ARLINGTON AVENUE BRIDGES REPLACEMENT

Design Review Committee Meeting #7 | November 8, 2022

Purpose of Today's DRC Meeting:

TMWA (Thomas Speer, Steve Volk)

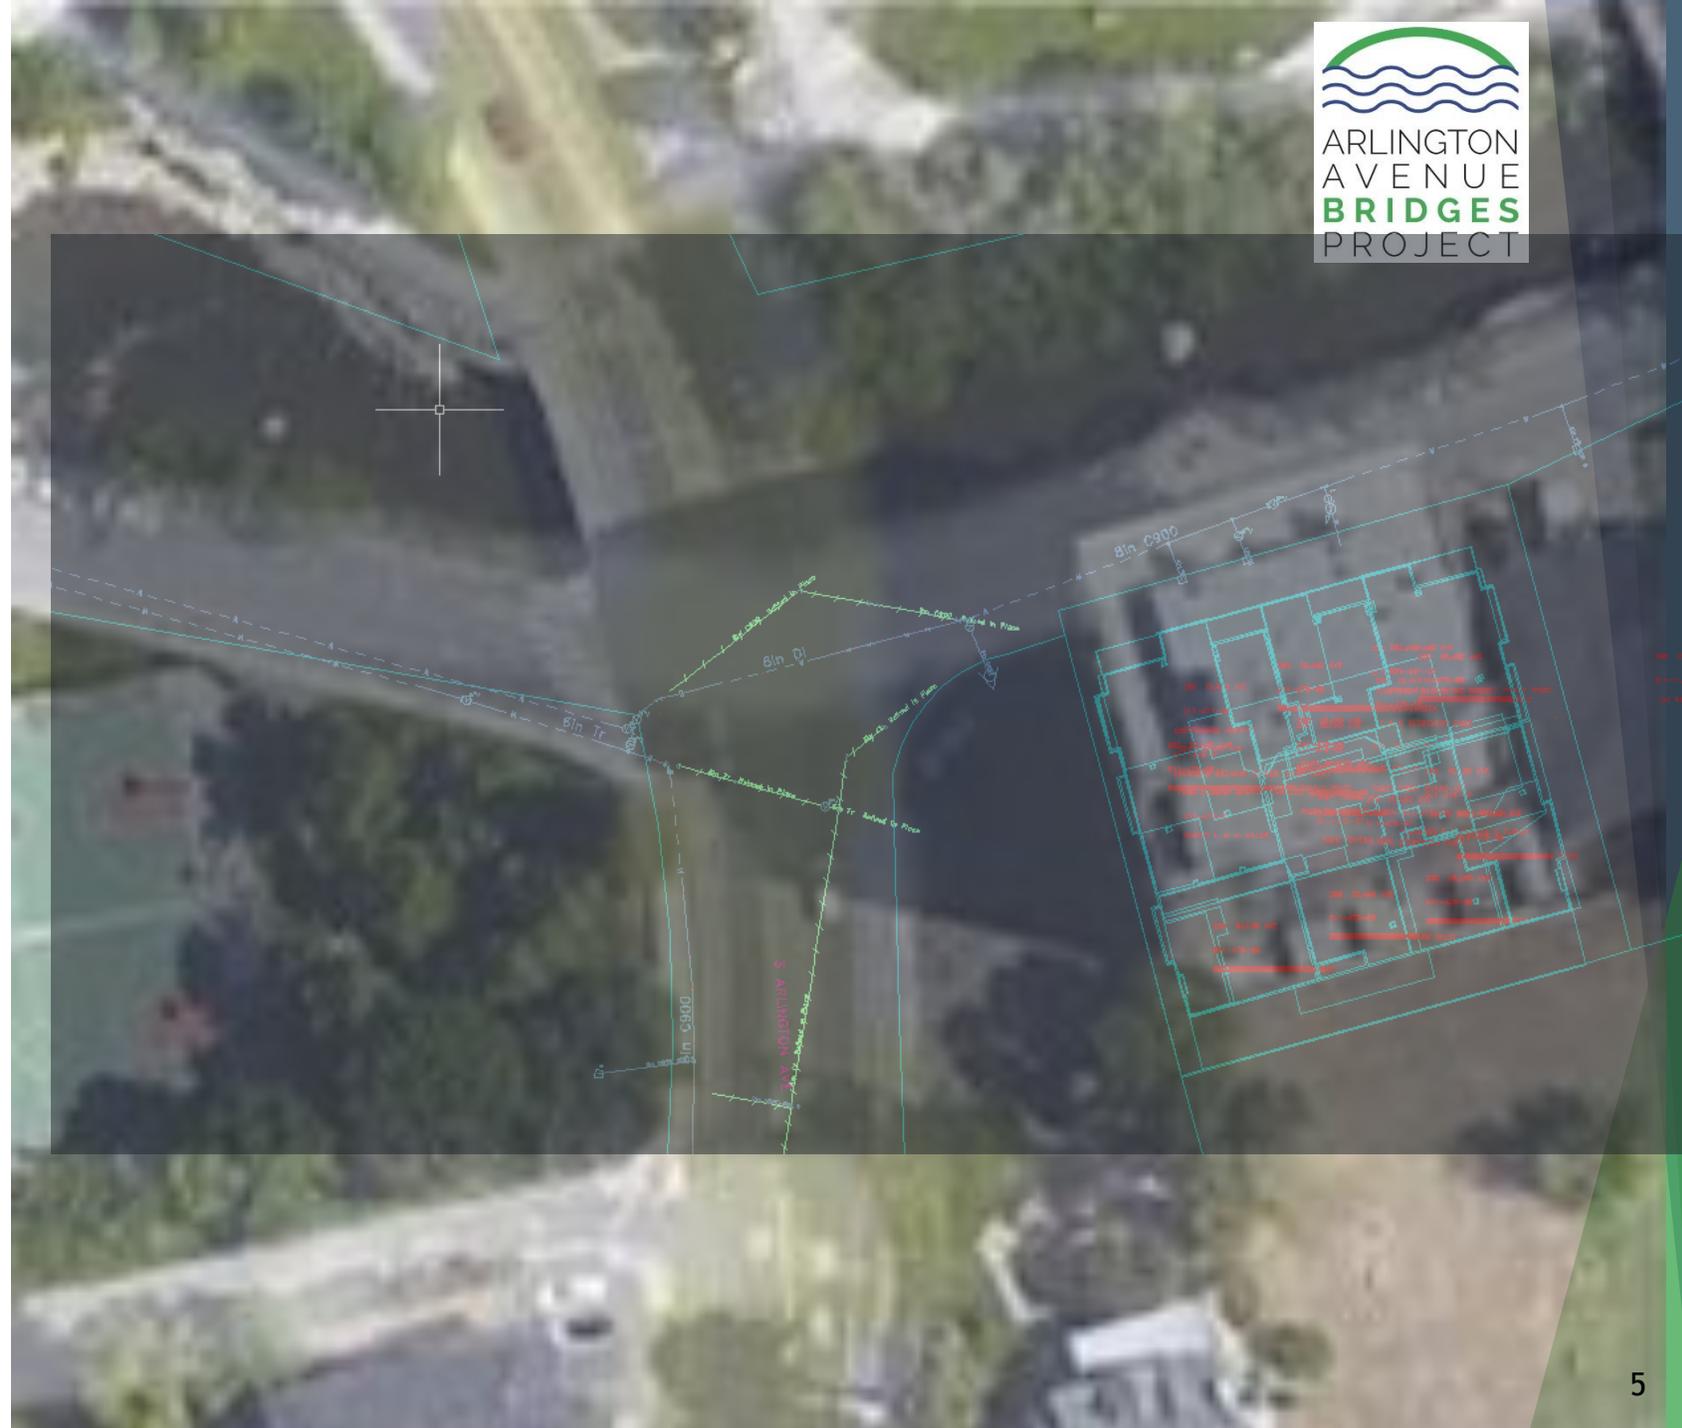
- 8-in Cast Iron within W. 1st Street intersection
- TMWA to replace/realign prior to construction; currently under design
- Protect in Place During Construction - Specification Requirements
- West of Intersection:
8-in Ductile Iron
w/ 2-in HDPE lateral
- East of Intersection:
8-in Transite
- North of Intersection:
8-in Cast Iron along west side
- Assume Park Irrigation Line from this 2-in HDPE lateral

NVE - GAS (Becca Epstein)

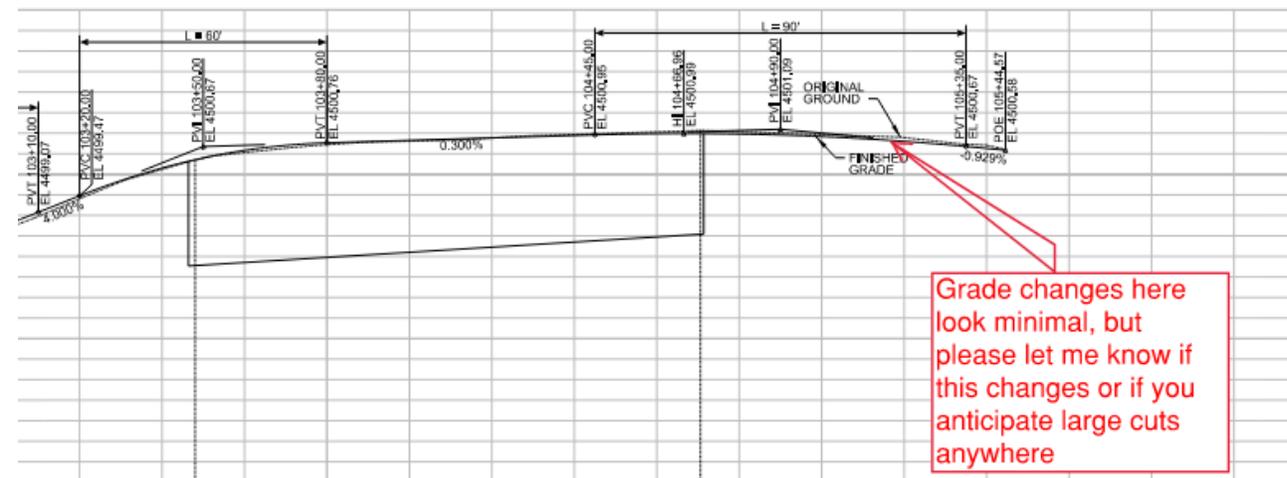
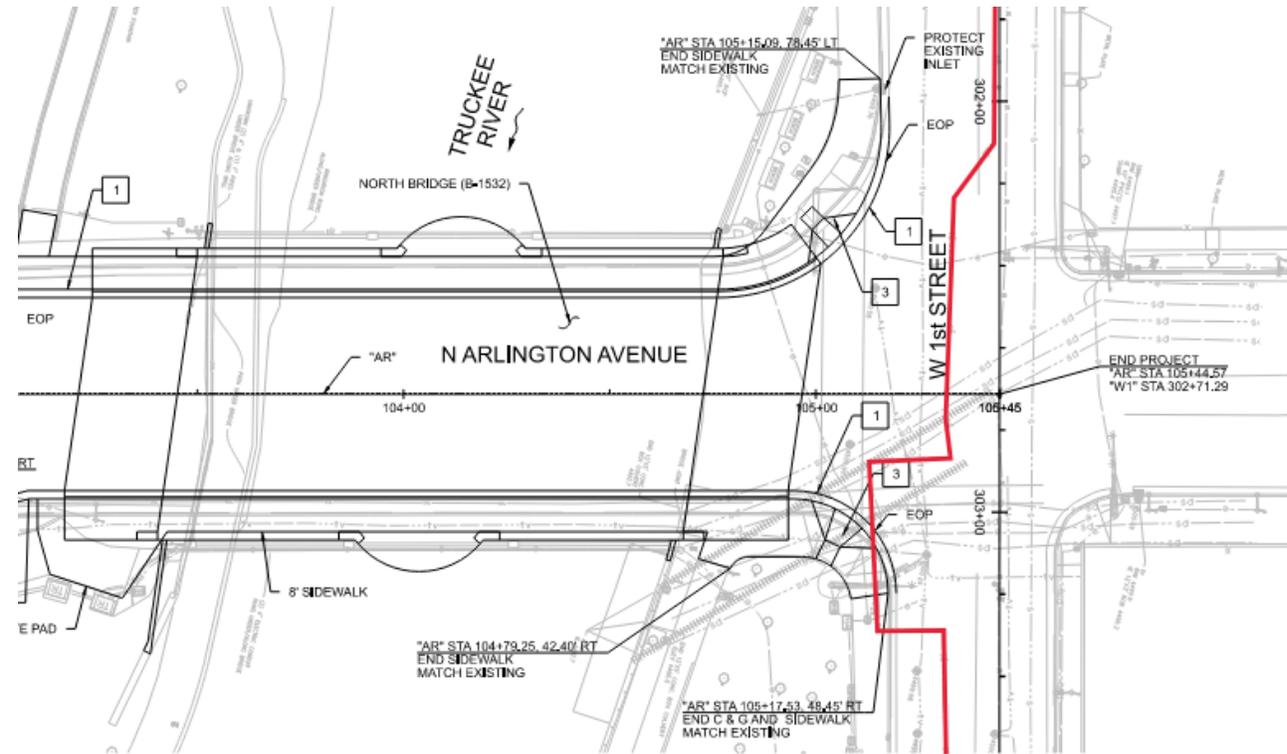
- ✓ Existing along W. 1st St.
- ✓ Protect in Place w/ Excavation for Bridge Abutment - Requirements for specifications

Grade changes here look minimal, but please let me know if this changes or if you anticipate large cuts anywhere

NVE - ELECTRIC (Benjamin Eide-Hughes)

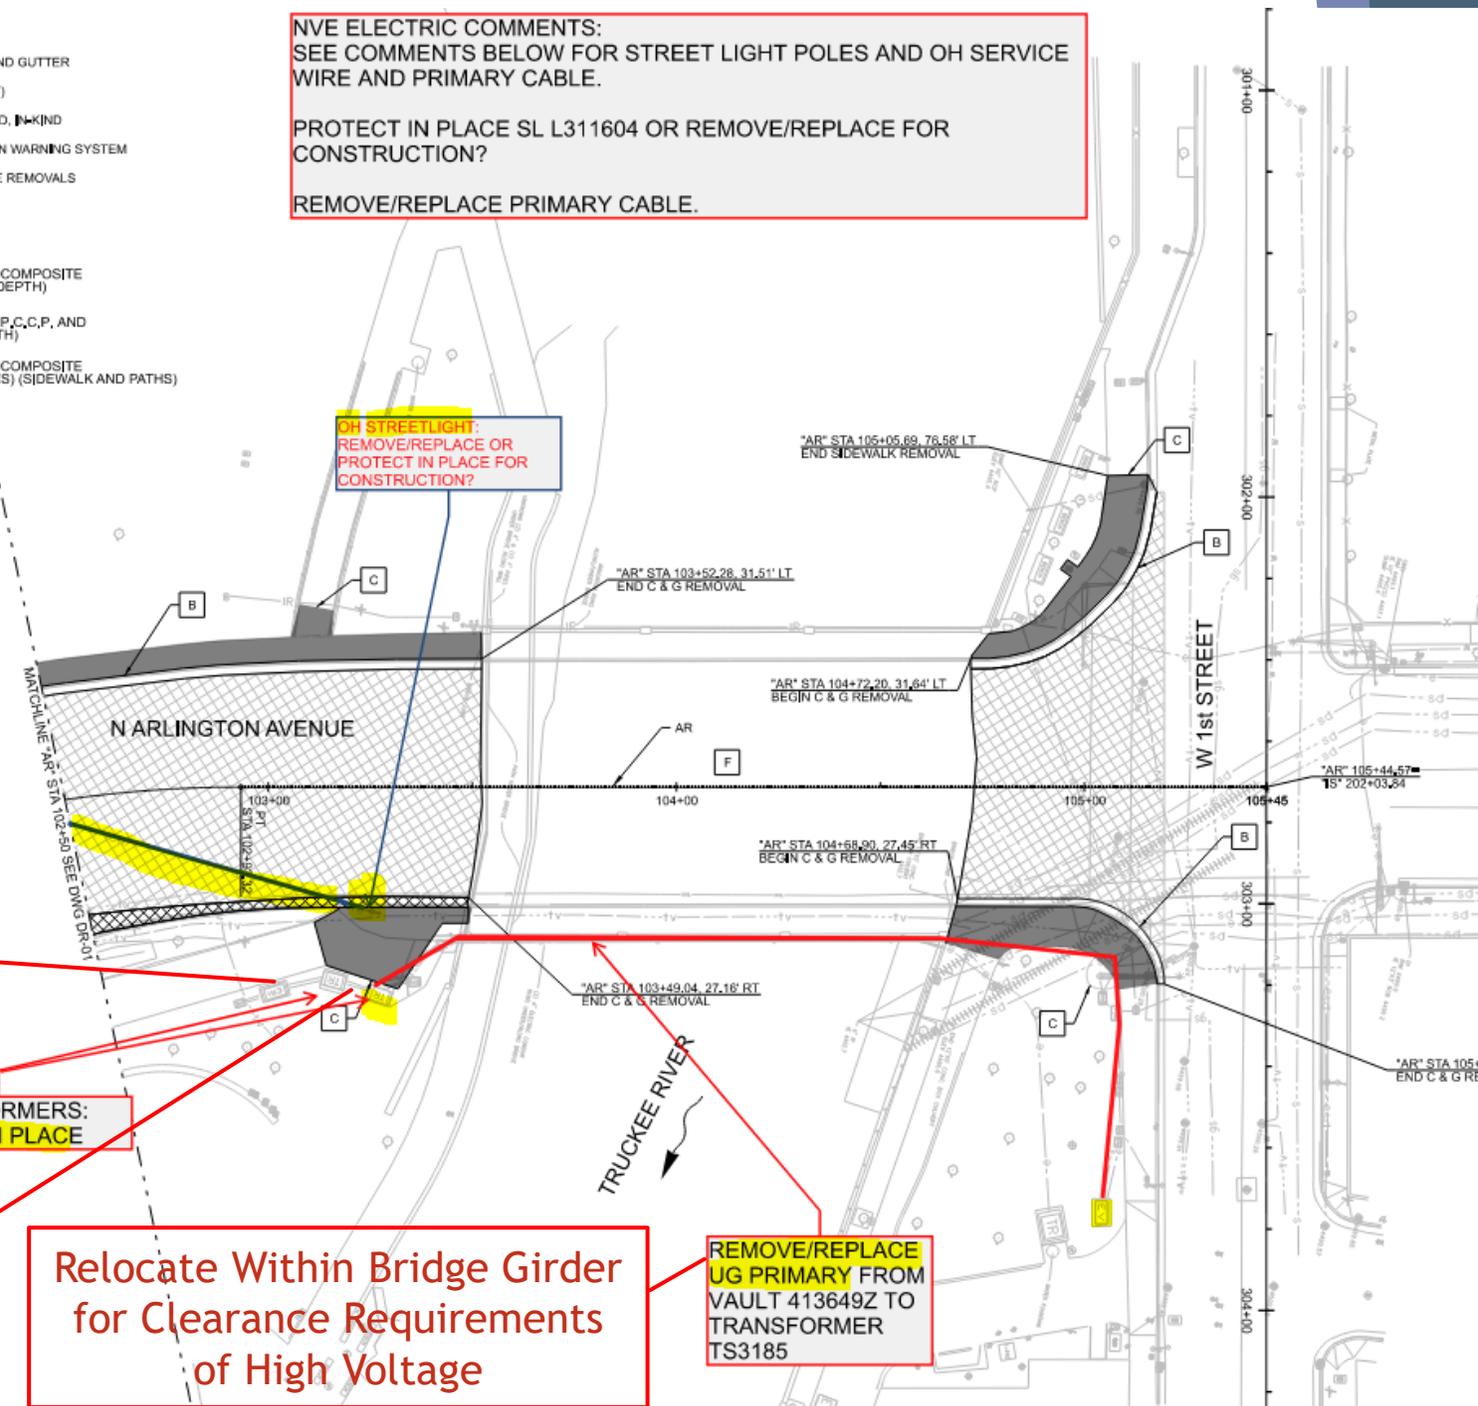
NVE ELECTRIC COMMENTS:
SEE COMMENTS BELOW FOR STREET LIGHT POLES AND OH SERVICE WIRE AND PRIMARY CABLE.

PROTECT IN PLACE SL L311604 OR REMOVE/REPLACE FOR CONSTRUCTION?

REMOVE/REPLACE PRIMARY CABLE.

2-TRANSFORMERS:
PROTECT IN PLACE

NVE Transformers (2)
Middle One is Empty - Can be removed or repurposed

Relocate Within Bridge Girder for Clearance Requirements of High Voltage

REMOVE/REPLACE UG PRIMARY FROM VAULT 413649Z TO TRANSFORMER TS3185

NVE - ELECTRIC

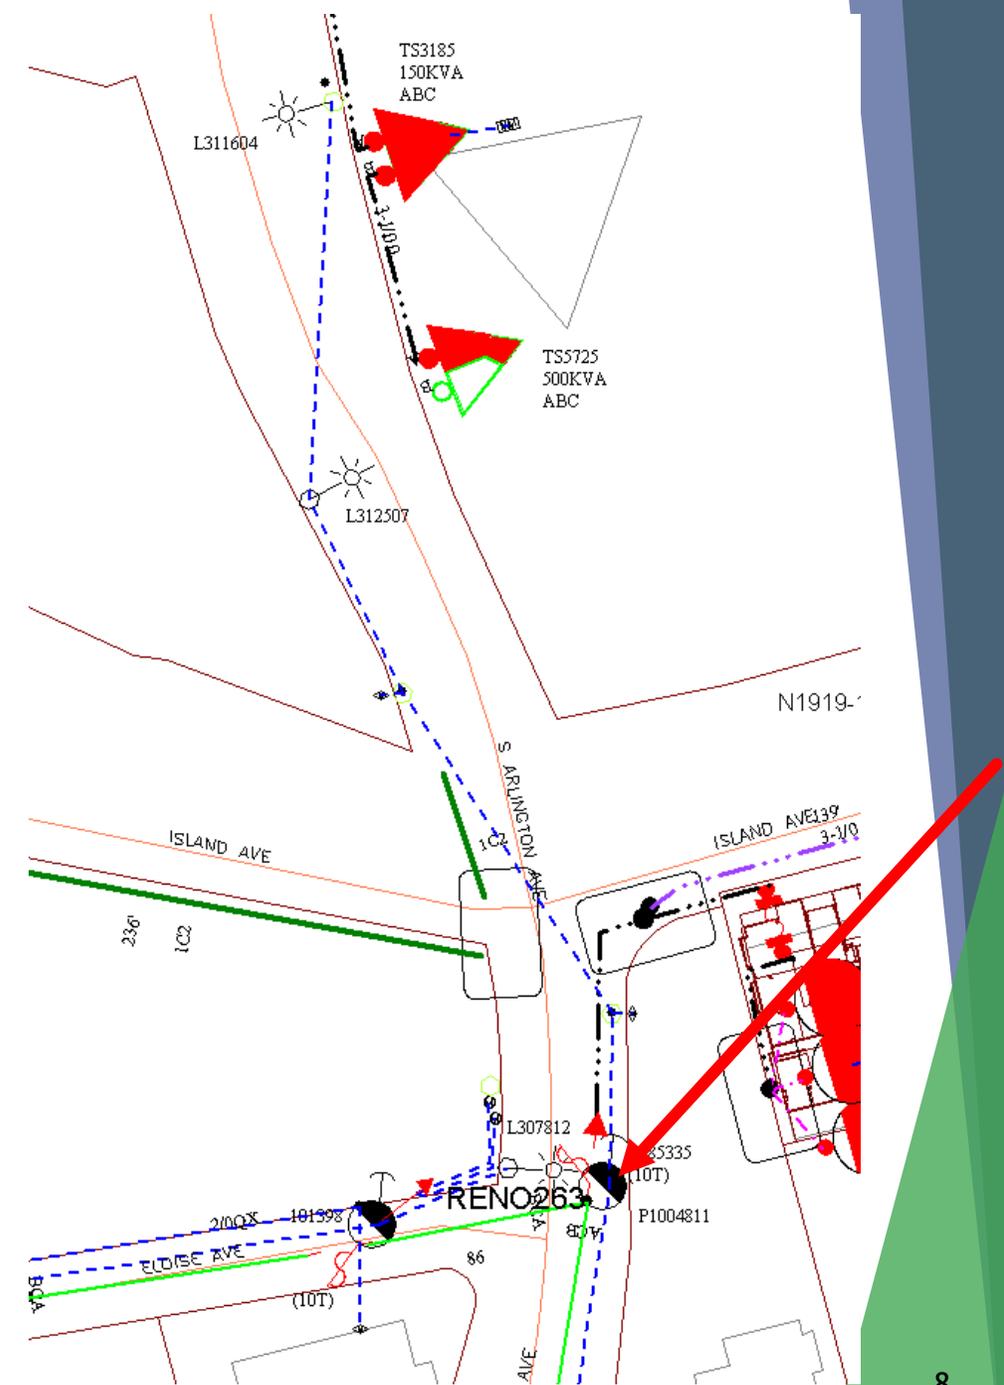
- Underground the existing Overhead
- Pole - P1004811 at end of Elsie Ave.

ZAYO (Gary Getchell, Robert Alford)

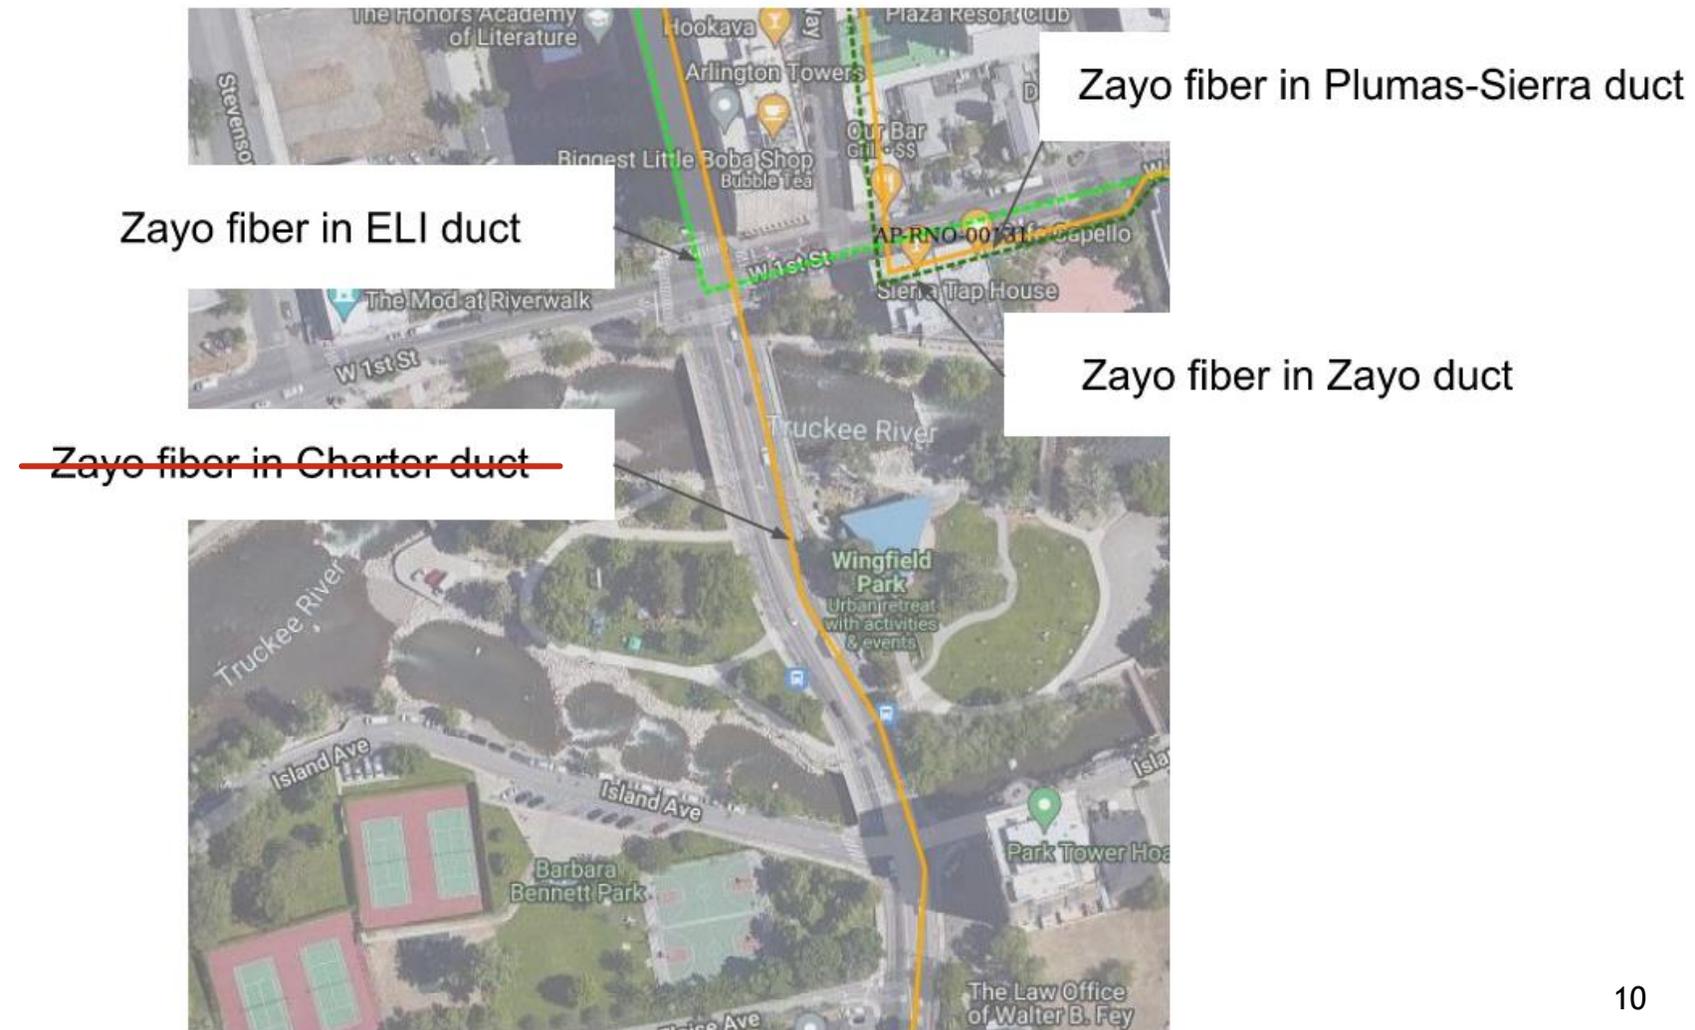
- * No Zayo Fiber in Charter Duct across South Bridge to Amphitheater
- * Zayo would like to have conduit across both bridges and along Arlington between bridges; 2-2" min
